JOB NO. 198 DRG. NO. J1

DESCRIPTION: EXP. JOINT - PIER 1

JOB: US ROUTE 5 OVER I-91 HARTLAND, VT.

VENDOR SUBMITTAL REVIEW

EXP. JOINT EJ1 - ONE REQ'D (@ PIER 1)

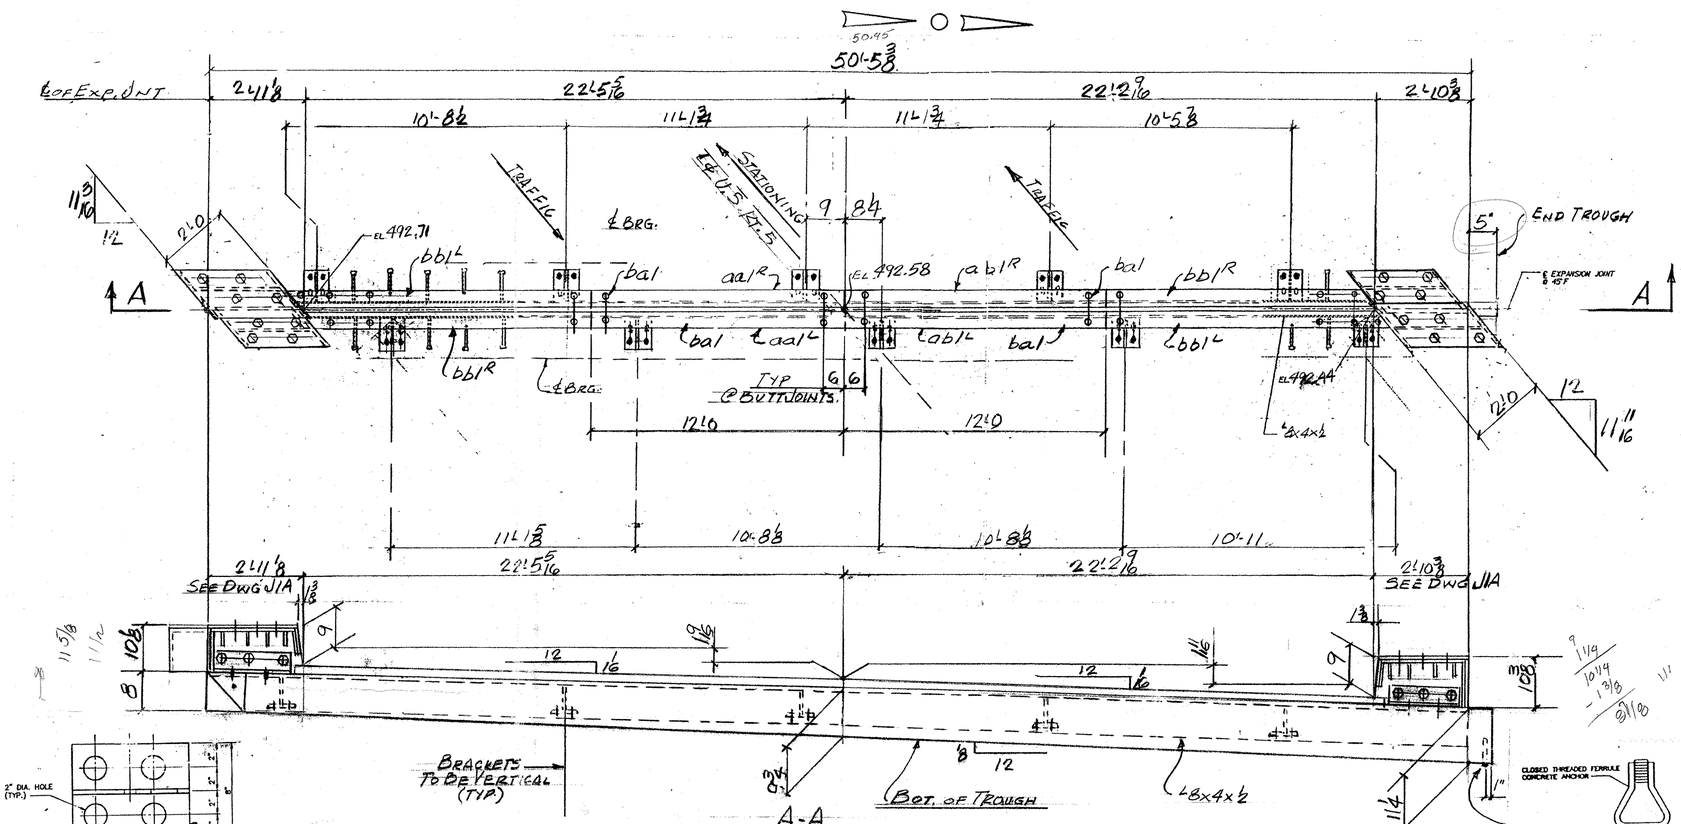
TROUGH SHALL BE SLOPED TOWARD LOW SIDE OF BRIDGE (right to left, opposite that of the joint) AT 1% FOR POSITIVE DRAINAGE
